## MEMORANDUM

To: David E. Griffith, PE  
 From: Reneé Whittenberger, PE, RSP1 and Sela Jones, EIT  
 Date: January 30, 2025  
 Subject: Addendum to Report Recommendations

Upon providing a schematic plan of proposed countermeasures in the *TRU-SR 193-1.67 Roadway Segment Safety Improvement Study*, project team members met with stakeholders to gather feedback prior to the request of implementation funding. The following recommendations were provided in the report:

Upon receiving input from members of the Township, the project team has created a revised plan of proposed countermeasures which is to be utilized for the request of implementation funding. These changes are clarified herein:

## OHIO DEPARTMENT OF TRANSPORTATION

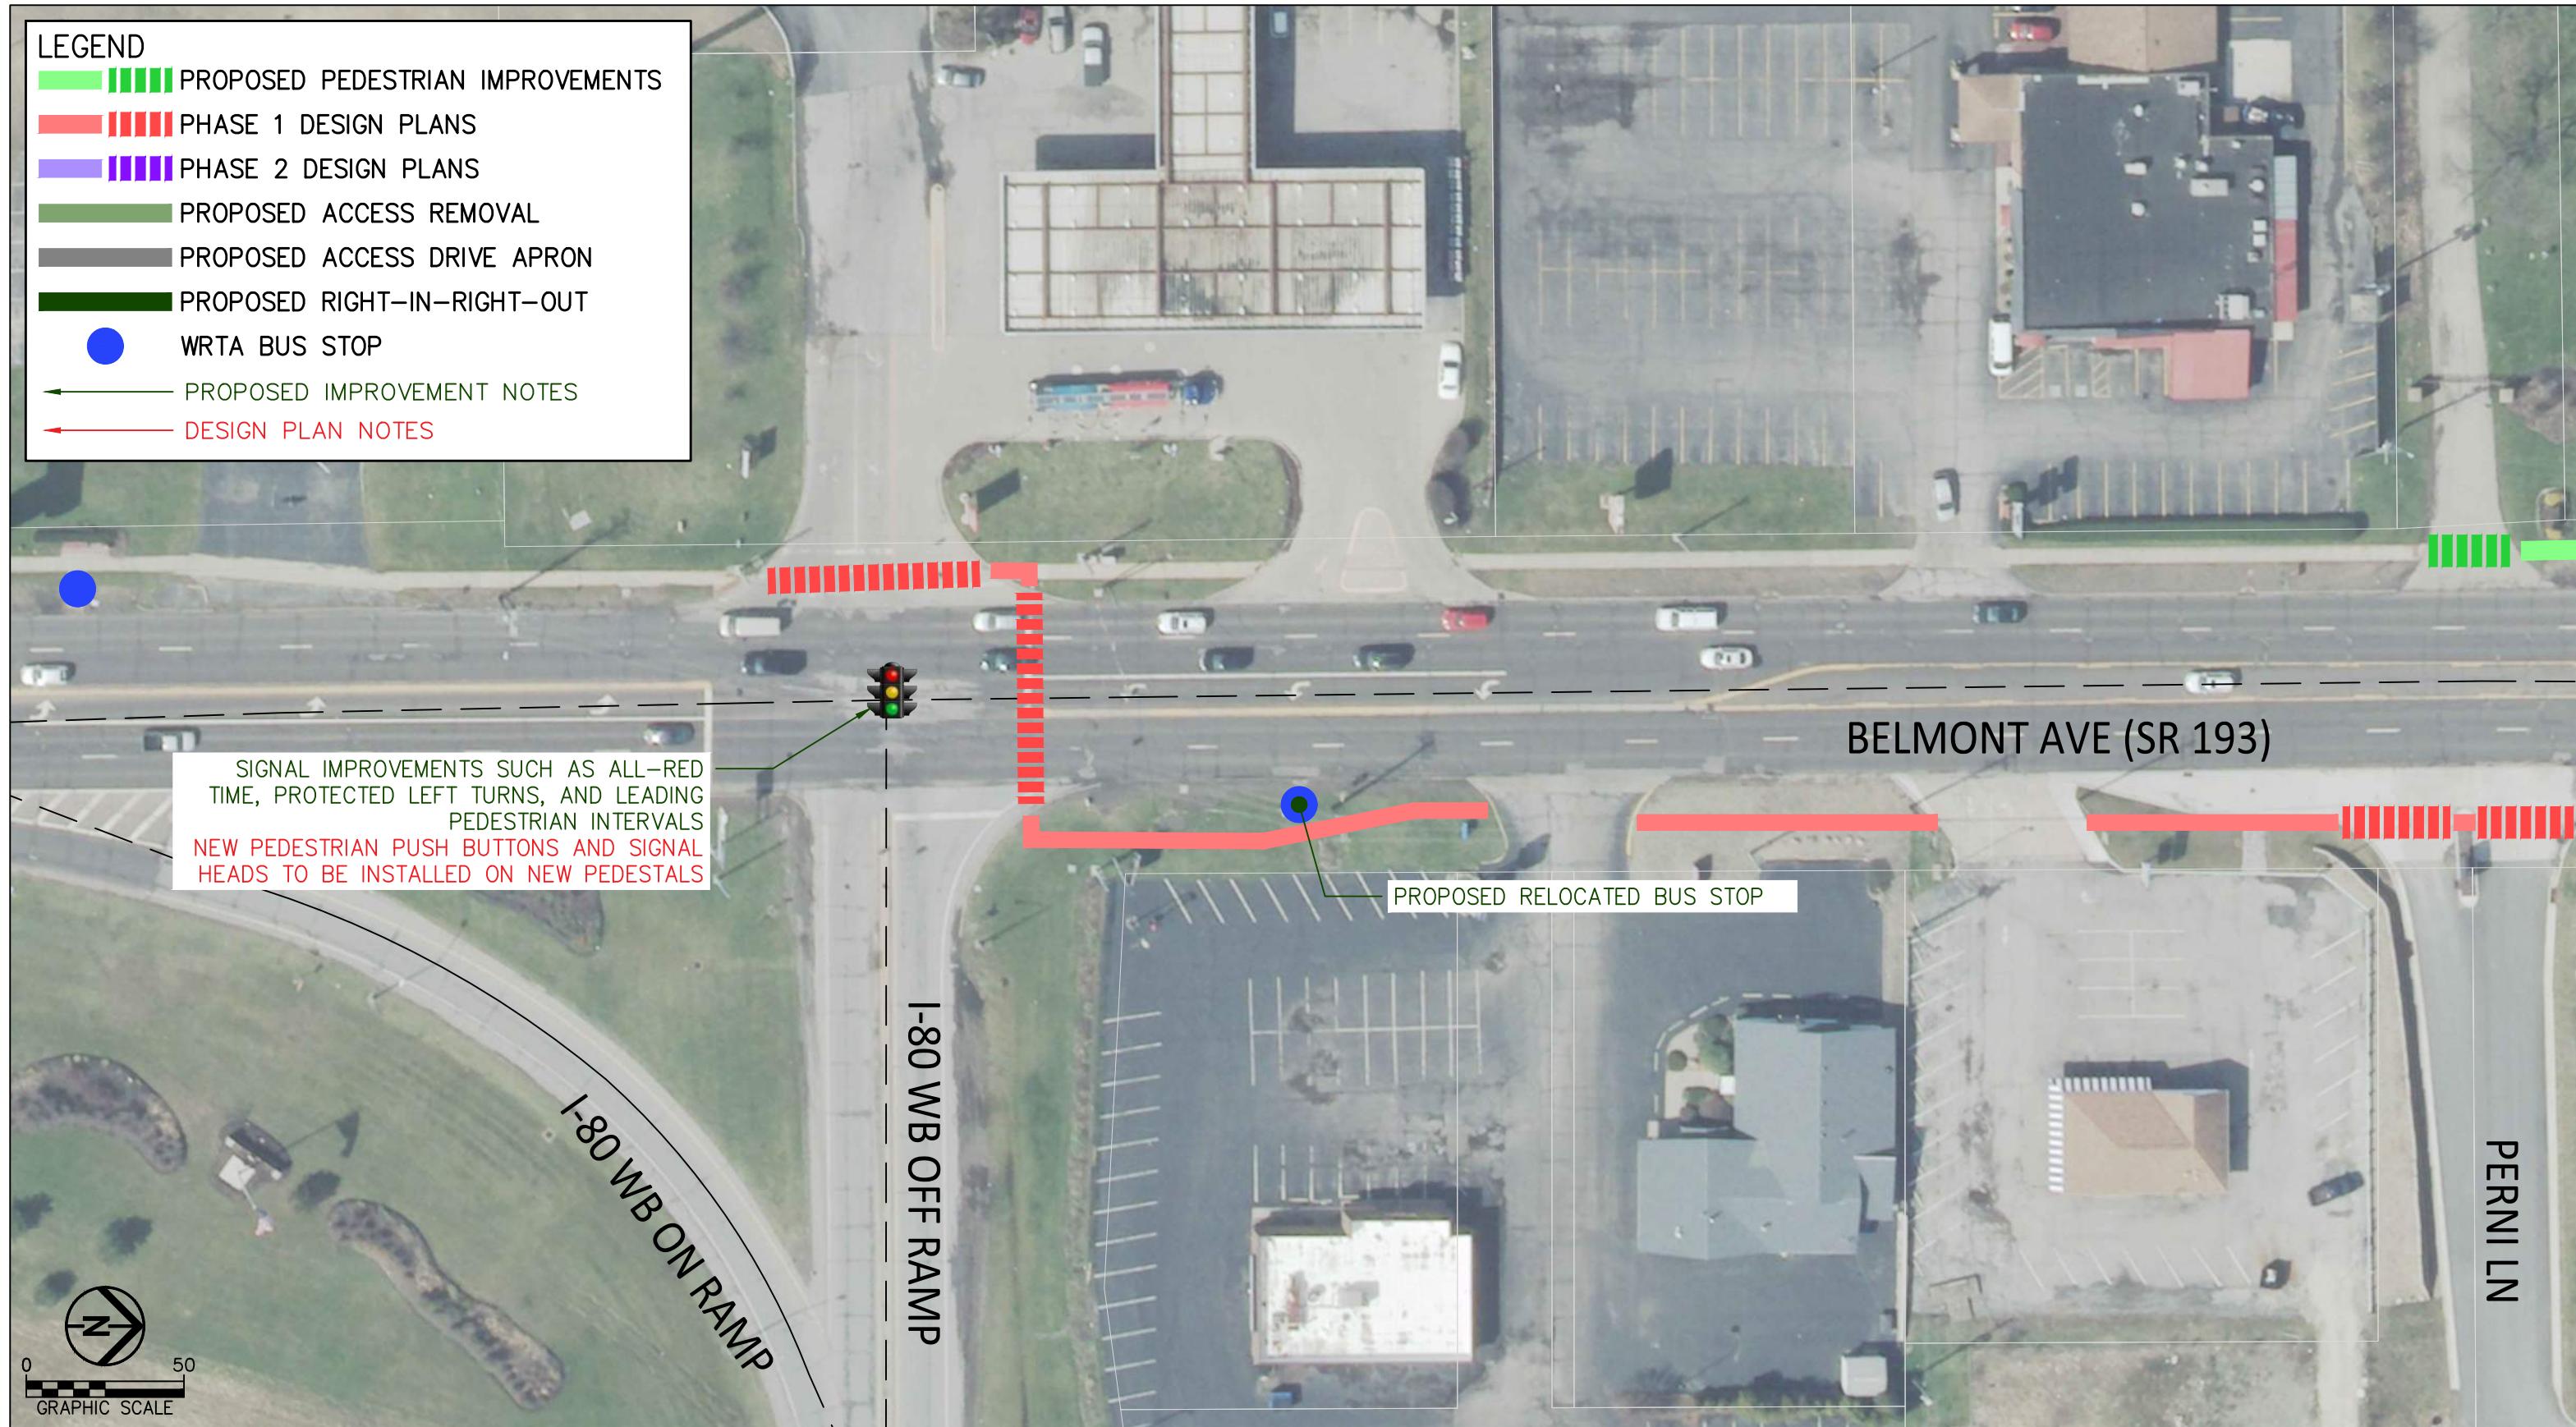
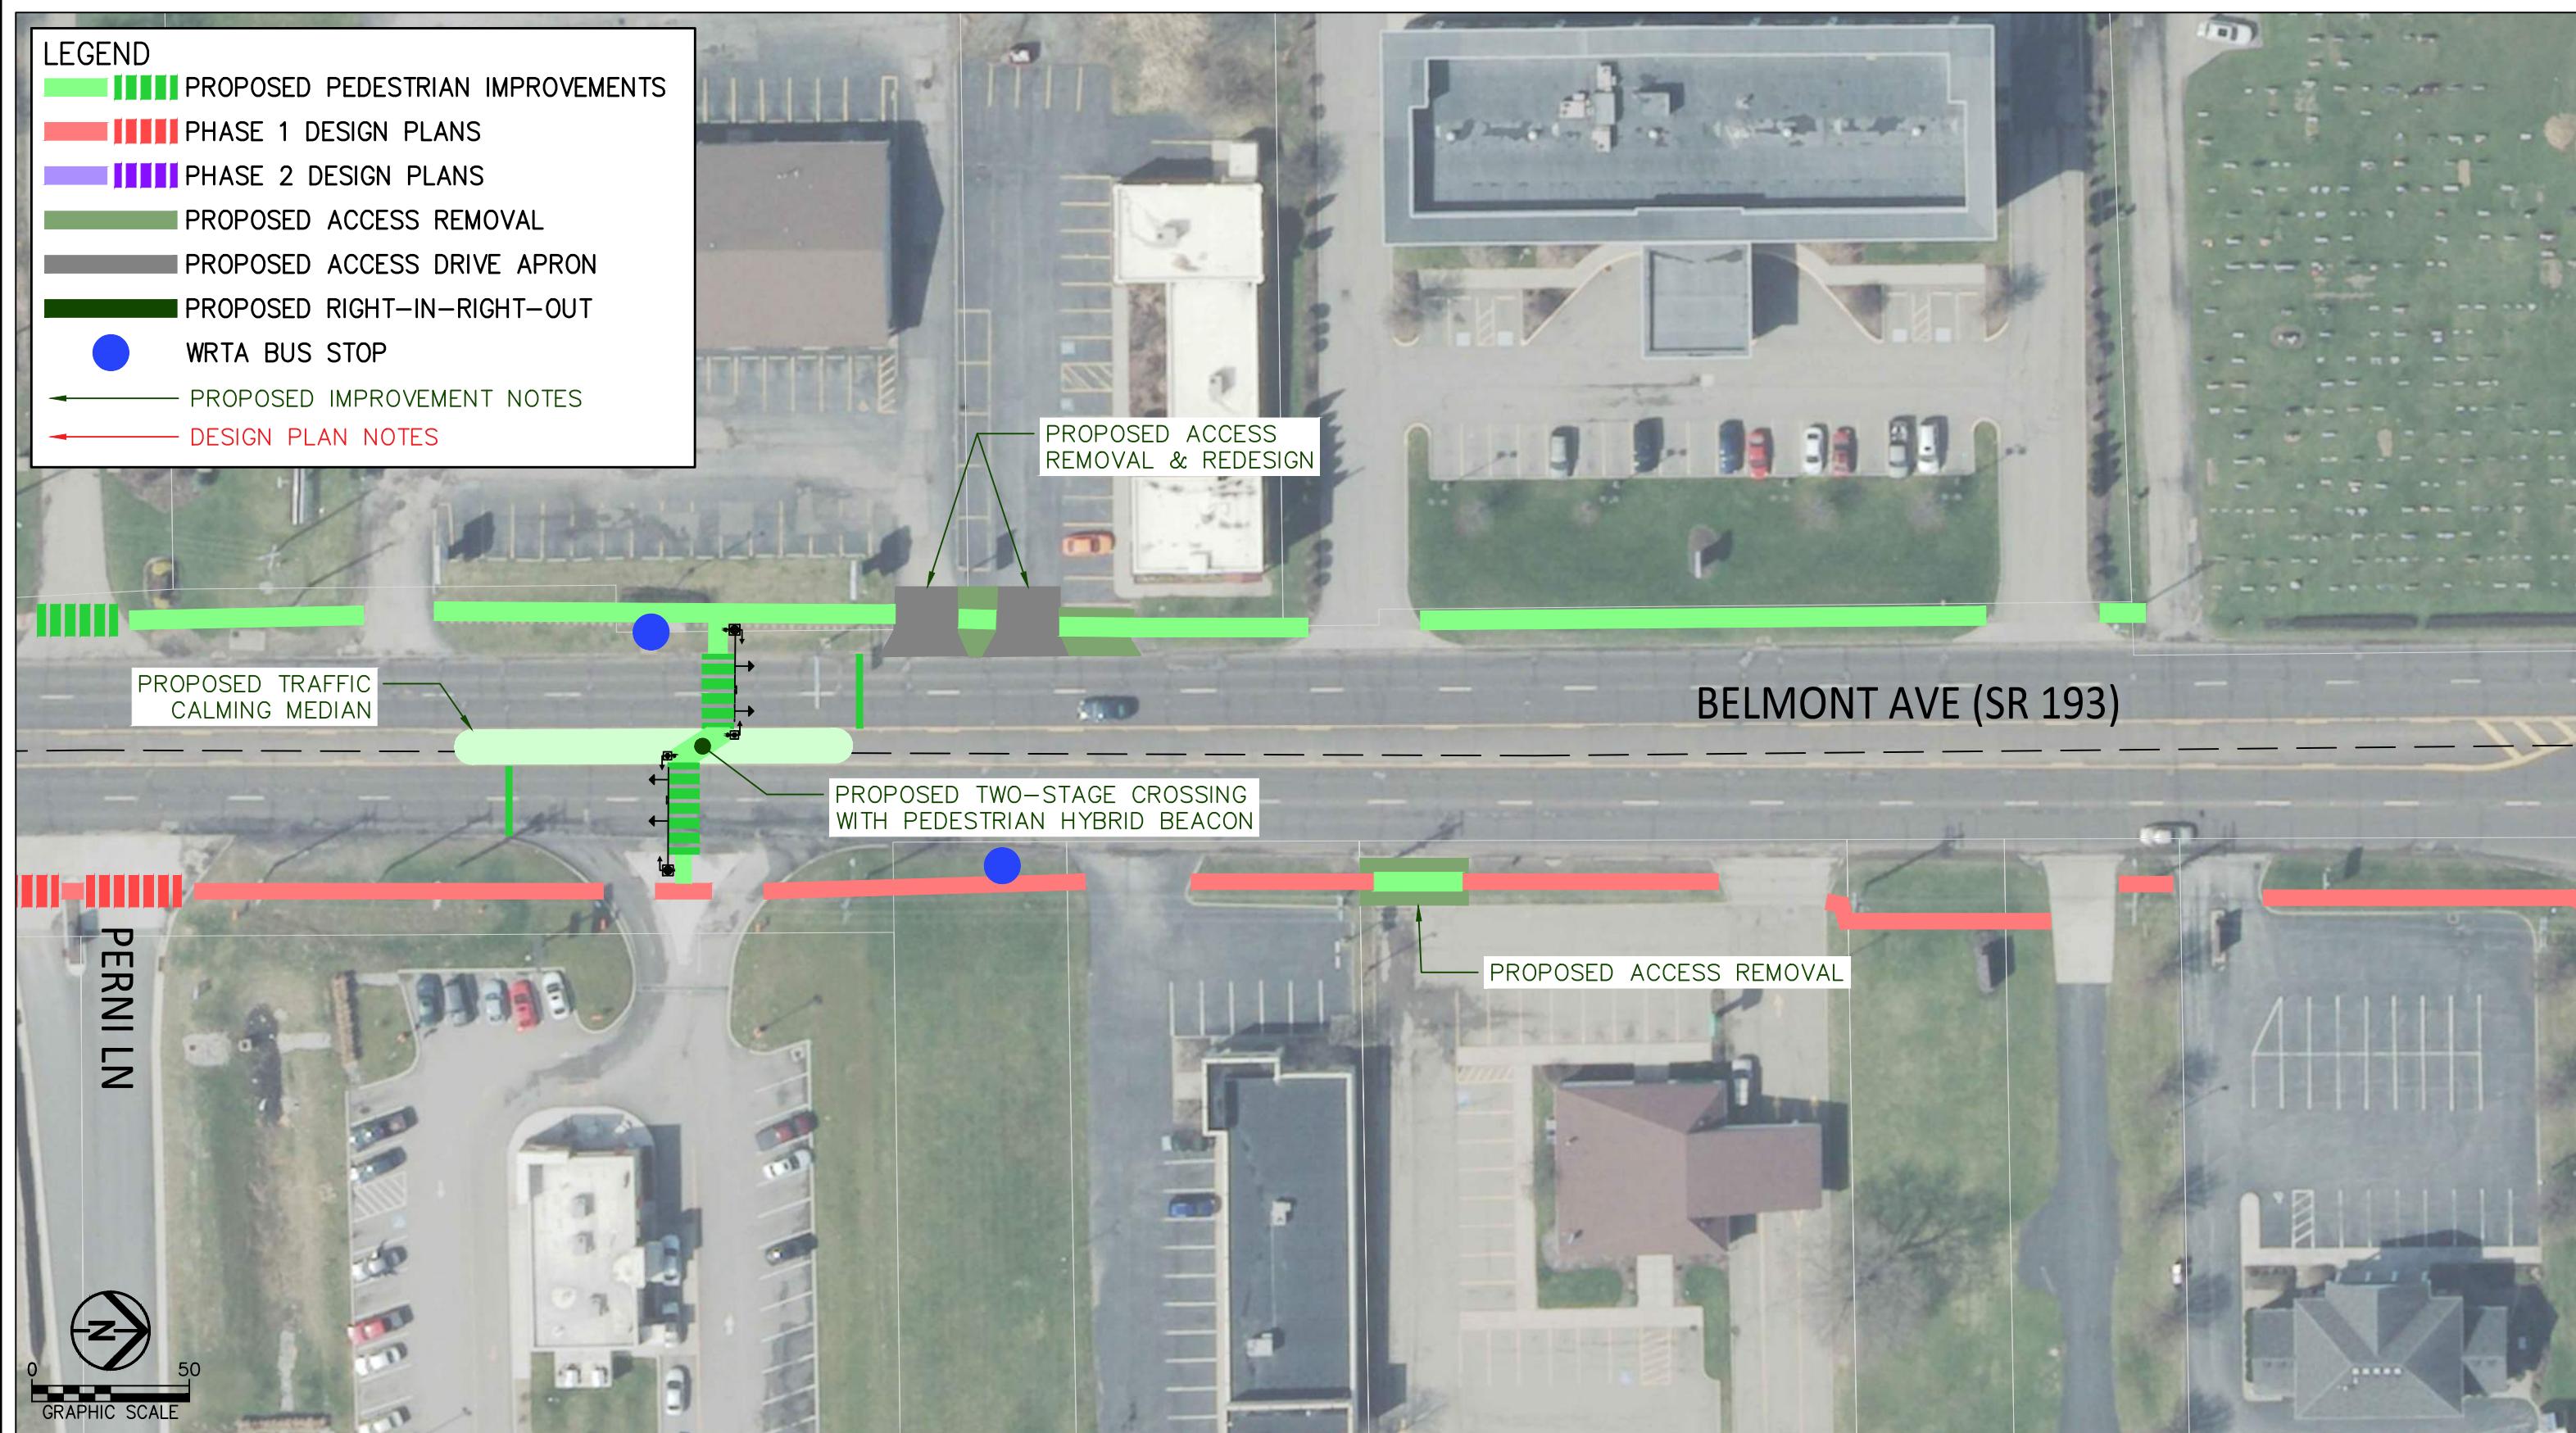
- Members of the Township expressed disinterest in providing sidewalk on the east side of SR 193 in proximity to the I-80 overpass, due to concern that the proposed infrastructure will encourage pedestrian activity near high-speed vehicles preparing to enter I-80. This includes the eastbound ramp south of the overpass and the slip lane which transitions into the westbound ramp north of the overpass. Presently,

the only amenity for pedestrians in this area is the *Belmont Avenue & Motor Inn Drive WRTA* bus stop. Stakeholders discussed their interest in moving this bus stop north of the westbound I-80 ramps in hopes of discouraging pedestrian traffic in the vicinity of high-speed vehicles preparing to enter I-80. This feedback has resulted in the removal of proposed sidewalk, crosswalks, and a rectangular rapid flashing beacon (RRFB) in this area. As a result, **the new sidewalk on the east side of SR 193 is now proposed to begin at Liberty Street and end at the entrance to the Baymont by Windham entrance.**

- Members of the Township expressed disinterest in removing access at the Speedway gas station across from the westbound I-80 ramps, due to the concern that incoming trucks will lose the ability to maneuver into the establishment. Also, the existing access point contains a median which facilitates right-in right-out movements. The project team agrees that this entrance can remain in its existing configuration. As a result, **access removal at the Speedway entrance is no longer proposed.**

- Members of ODOT District 4 expressed concern over the access management proposed for the restaurant property on the west side of SR 193 south of the I-80 overpass. Due to the multiple existing access points at the property, which increase exposure for crossing pedestrians, project team members recommended one shorter access point available at the north end of the lot. However, ODOT District 4 was concerned over the possibility of exiting patrons' ability to cross five lanes of traffic through the gap in the median in hopes of traveling northbound on SR 193 or entering the eastbound I-80 ramp. As a result, **the new access point of the restaurant property south of the I-80 overpass is now recommended for the south end of the lot, as this configuration utilizes the existing median to limit movements to right-in right-out only.**

- In the interest of maintenance and cost, **replacing the median** between the I-80 overpass and the I-80 westbound ramp intersection **was not preferred. The existing median will remain.**
